**MODIFICATION REQUEST:  
Internal and External Design Changes  
and Amendment to Conditions to Dr  
Chau Chak Wing Building  
14-28 Ultimo Road, Ultimo  
(MP09\_0153 MOD 3)**

Director-General's  
Environmental Assessment Report  
Section 75W of the  
*Environmental Planning and Assessment Act 1979*

April 2013

Figure 3: Proposed Ground Level Floor Plan

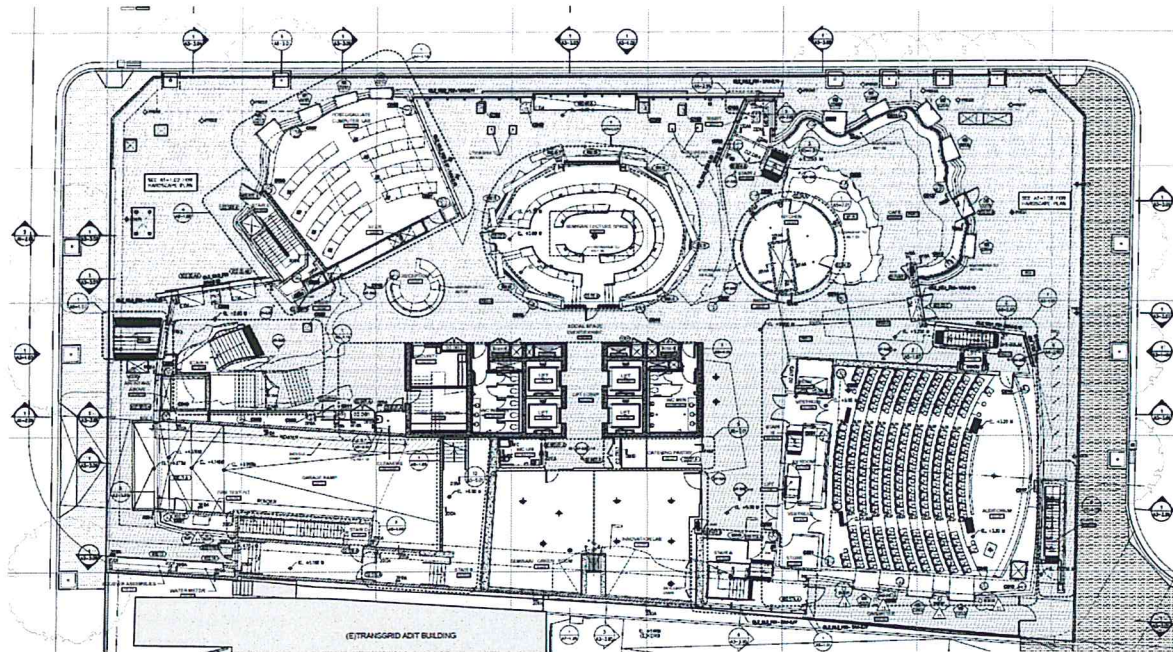
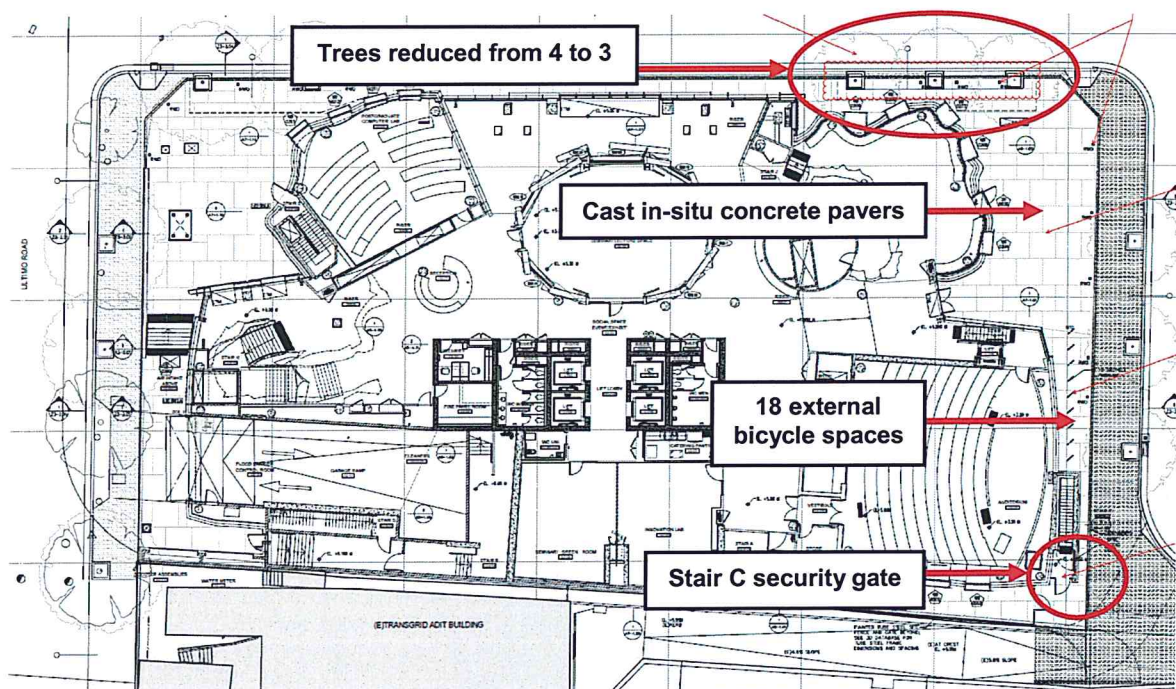
- Reducing the number of basement bicycle parking spaces from 171 spaces to 160 spaces;
- Increasing the number of external bicycle parking spaces from 16 spaces to 18 spaces on ground level;
- Removal of perimeter stormwater drain and addition of 13 individual rain water outlets on ground level;
- Changing the pavement material from asphalt block pavers to cast in-situ concrete pavers, with saw cut pattern on ground level;
- Reduction in trees on the northern end of Omnibus Lane from 4 trees to 3 trees;
- Increasing the wall height of Stair C from 1.2 m to 1.8 m for safety reasons;
- Addition of a security gate to Stair C on ground level to increase safety;
- Deletion of the tri-generation plant and the cooling tower, and the addition of three air cooled chillers on level 13, and
- Increasing the sprinkler tank height by 600 mm on roof level.

Council raised no objection to the proposed modifications. Notwithstanding, council requested that all stone setts around all trees be removed as they are only required when placed in granite paving, and therefore not necessary. The proponent has agreed to council's request.

The modification application seeks to delete the perimeter stormwater drain on ground level due to potential blockages and trip hazards. Thirteen individual rainwater outlets are sought to be placed around the site in lieu of the perimeter drain to collect stormwater within the boundary.

The modification proposes to reduce the number of trees along the northern end of Omnibus Lane from four to three, to comply with council's request to allow a 6 metre separation between the trees. Council's submission confirmed the reduction in trees was required to allow sufficient spacing. The department considers this appropriate and it will not significantly alter the approved landscaping plan. In addition, council request the removal of all stone setts around all trees on site and on council land, as this detailing is no longer required by council. Accordingly, the department will condition the removal of all stone setts in the Instrument of Modification.

The proponent is seeking to replace the approved external asphalt pavers on ground level with cast in-situ concrete pavers, with a saw cut pattern in a natural concrete colour. This modification is pursued due to the unavailability of the approved material in Australia. The department considers the modification acceptable and the council has confirmed that it is consistent with the City of Sydney's Interim Sydney Street Design Code 2010.

One hundred and eighty seven bicycle parking spaces were approved under MOD 1, with 171 spaces within the basement and 16 on ground level. This was as result of minor reconfiguration of rooms within the basement which allowed extra bicycle spaces. The subject application proposes to decrease the number of bicycle spaces by 9, with 160 bicycle spaces available within the basement and 18 along Mary Ann Street. The department considers the proposed modification acceptable as it still exceeds the required amount that was approved in the original project application (177).

The department requested additional information from the proponent on 6 March 2013 confirming that the proposed modification can cater for a 1 in 20 year storm event. The proponent's drainage consultant AECOM, confirmed in a letter dated 20 March 2013, that the revised drainage system has the capacity to collect rain fall runoff from a 1 in 20 year storm event. Notwithstanding, it did acknowledge in some instances, rain water may bypass the site's drainage system and be collected in the council kerb and gutter. The department is satisfied with the additional information provided and notes council accepts such potential overflow situations. In addition, the department considers the revised design appropriate to mitigate the risk of trip hazards associated with the perimeter drain.

Figure 4: Thirteenth Floor Plan

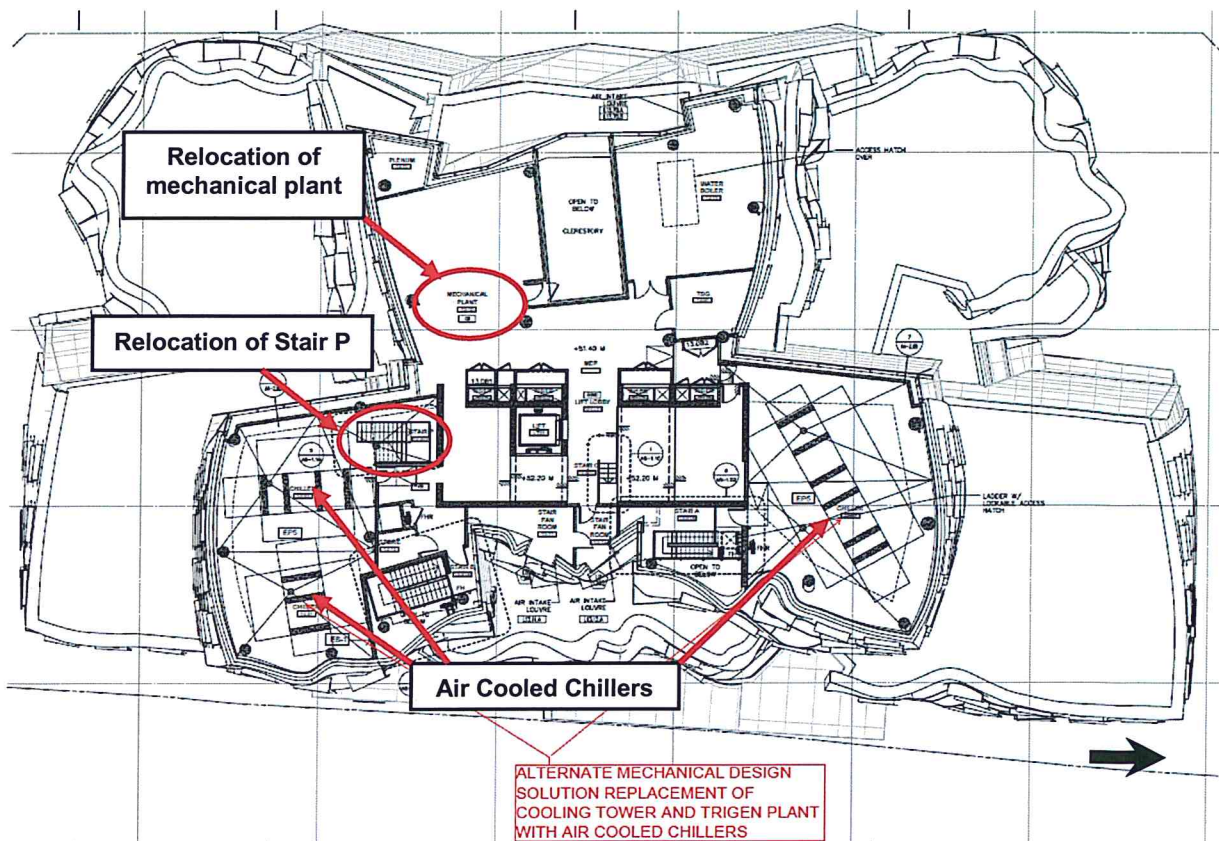
The original application implemented the tri-generation system and cooling tower as part of the building's ESD concept approach. MOD 3 seeks to substitute the tri-generation plant and cooling tower on level 13 with three air cooled chillers following an assessment of the engineering process. As a result, minor reconfiguration to the plant rooms are necessary to accommodate the air cooled chillers. Access to the roof via Stair P is to be relocated a few metres to the west and the mechanical plant relocated to the western portion of the building (see Figure 4).

A revised ESD report prepared by AECOM and dated 19 March 2013, concludes that an overall weighted score of 65.4 points will be achieved as a result of the proposed modification. This will result in a slight reduction from the original project application, which achieved 66 points. Notwithstanding, the proposed modification will ensure the building will still exceed the 60 points requirement for a 5 Star Green Star rating.

The department considers the proposed modification is acceptable as it will maintain a 5 Star Green Star building rating. The reconfigurations to the plant rooms are minor in nature, would improve its functionality, and have no external visual amenity impacts. Accordingly, all conditions relating to the tri-generation plant (conditions E6 to E8, F10 to F15, and F19) will be deleted from the Instrument of Approval.

Figure 5: Proposed Site Section

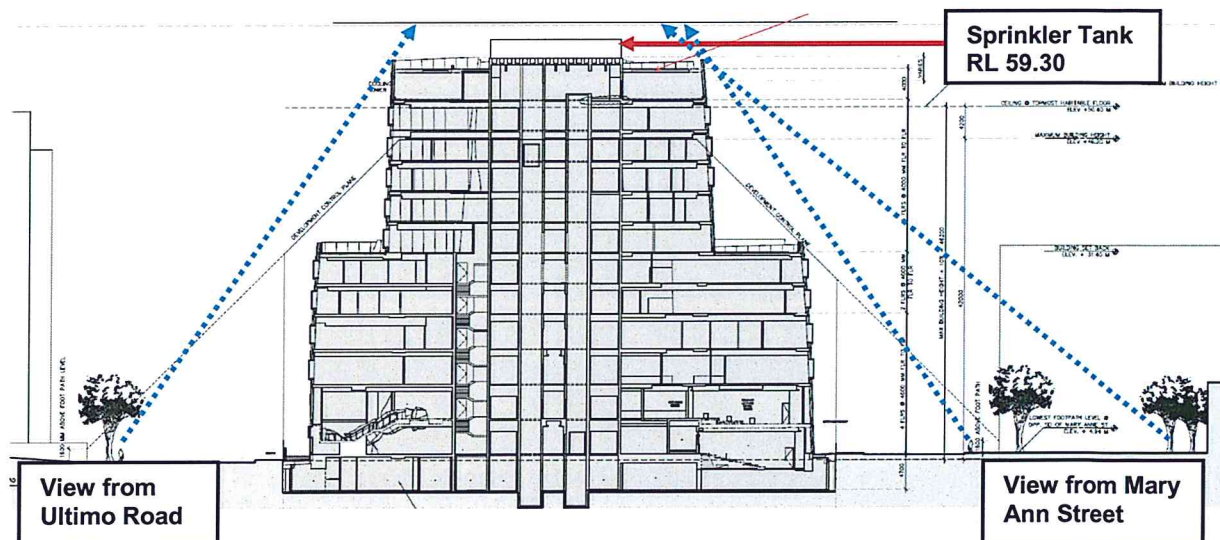
The approved building height, inclusive of the sprinkler tank on roof level, is RL 58.70. The proponent seeks a slight increase to RL 59.30. The modification request is the result of adding 600 mm structural piers to support the sprinkler tank.

The approved building exceeded the building height limit (42 m) set out by the Sydney Local Environmental Plan 2005 (Sydney LEP 2005). This was acceptable as Sydney LEP 2005 allowed a 10 per cent variation to building height. The Sydney LEP 2012 sets a maximum height of 33 m for the site (inclusive of sprinkler tank). When calculated as per requirements of the Sydney LEP 2012, the proposed building height would be 49.7 m. The department notes the provisions of Part 3A of the EP&A Act continue to apply for the site, and therefore prevail over Sydney LEP 2012. Further, council did not object to the height modification.

The approved building was considered to have an acceptable level of overshadowing impact on adjoining properties during the winter solstice. The department considers the minor height increase would have no further reduction in sunlight entering surrounding buildings as the additional shadow would only be created on the roof. In addition, no visual impacts would arise from the minor height increase of the sprinkler tank as it will be adequately obscured from public view due to its setback from the building façade. **Figure 5** depicts the setback of the sprinkler tank that may be perceived from Ultimo Road and Mary Ann Street.
